GNRO-2018/00012

SUBJECT: Proposed Revision of Grand Gulf Nuclear Station UFSAR – Replacement of Turbine First Stage Pressure Signals with Power Range Neutron Monitoring System Signals

Grand Gulf Nuclear Station, Unit 1
Docket No. 50-416
License No. NPF-29

Attachment 1 to GNRO-2018/00012
Evaluation of the Proposed Change

PARTIAL VIEW OF UFSAR FIGURE 7.2-001B (ZONE E-8)

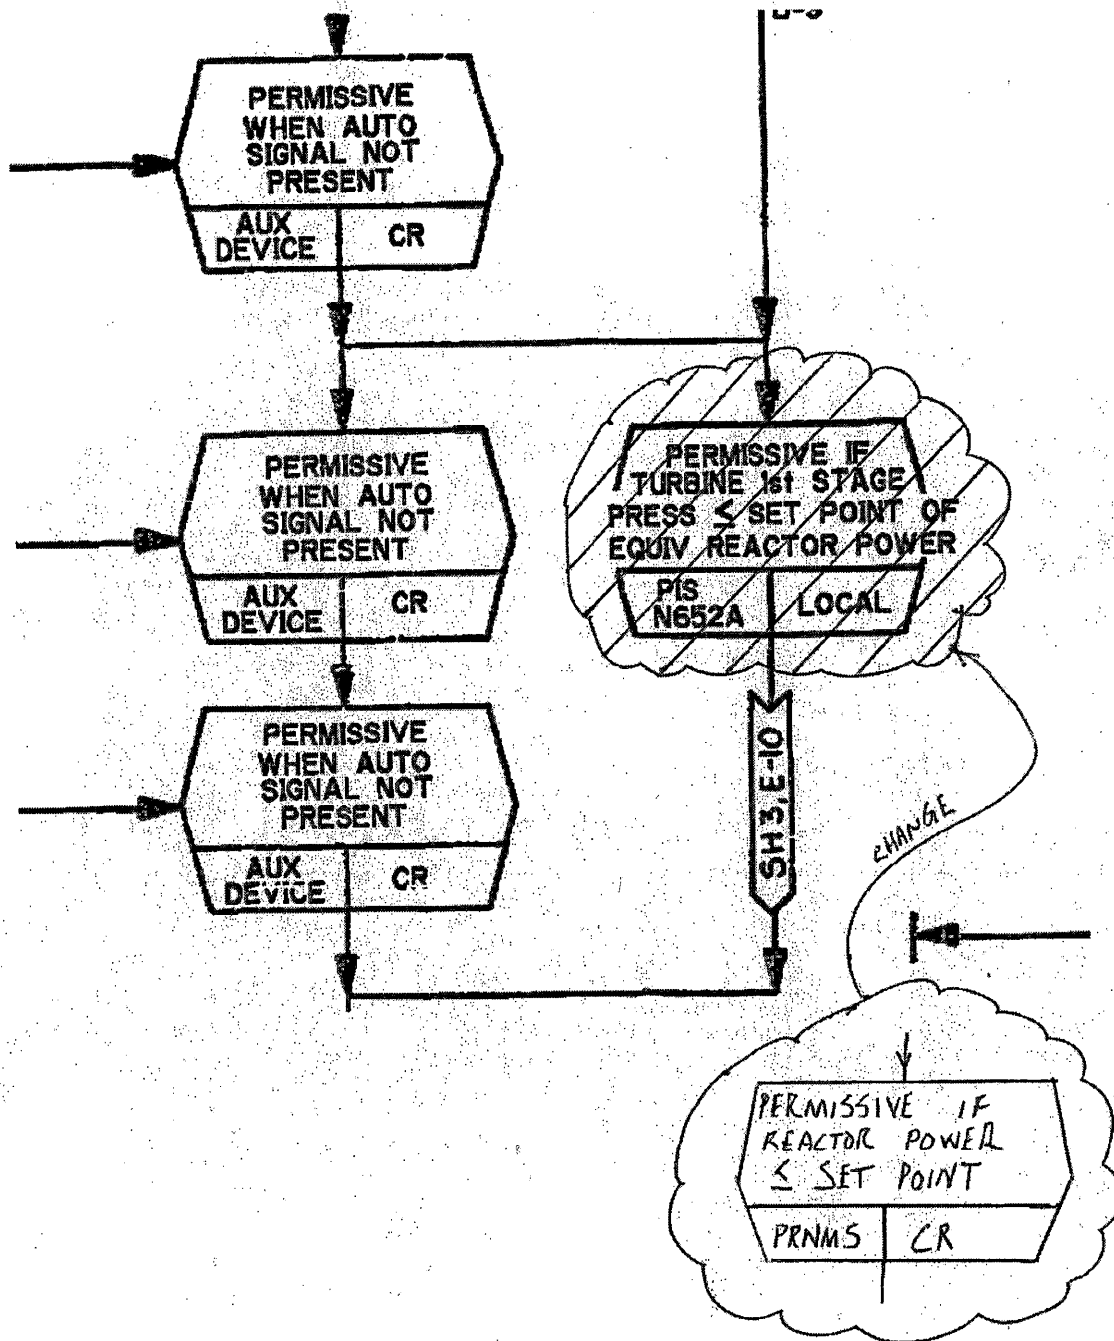
Figure 7.2-001B

PARTIAL VIEW OF FIGURE 7.2-001C (ZONE B-9)

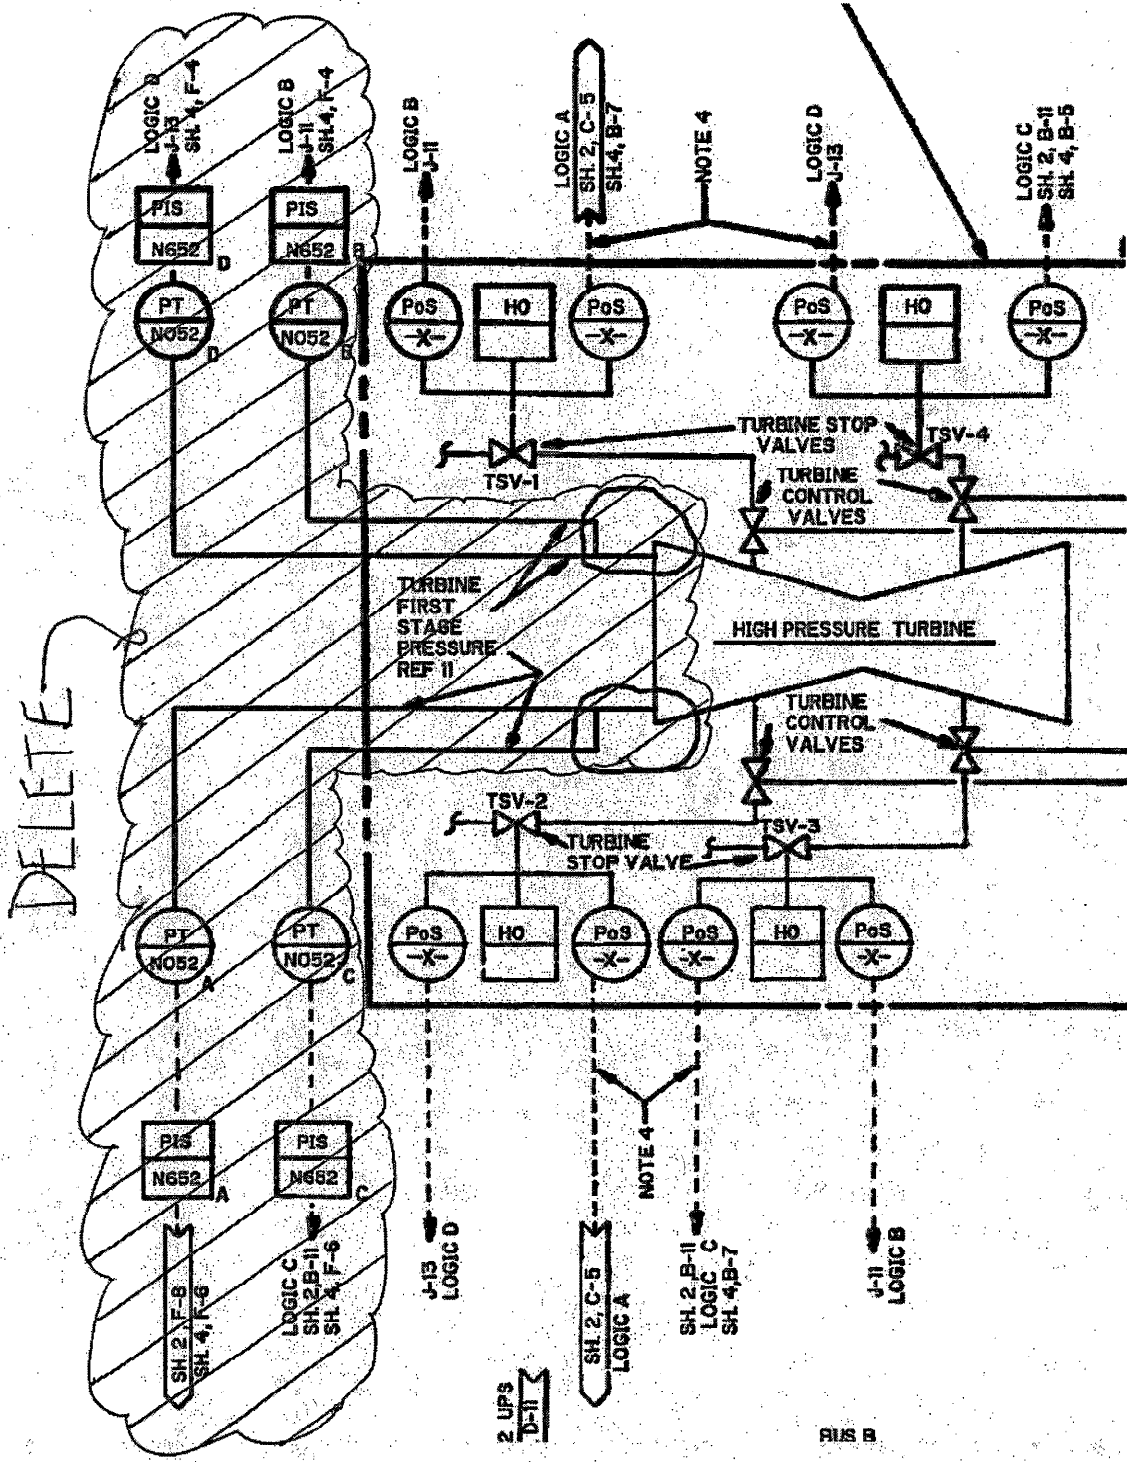
Figure 7.2-001C
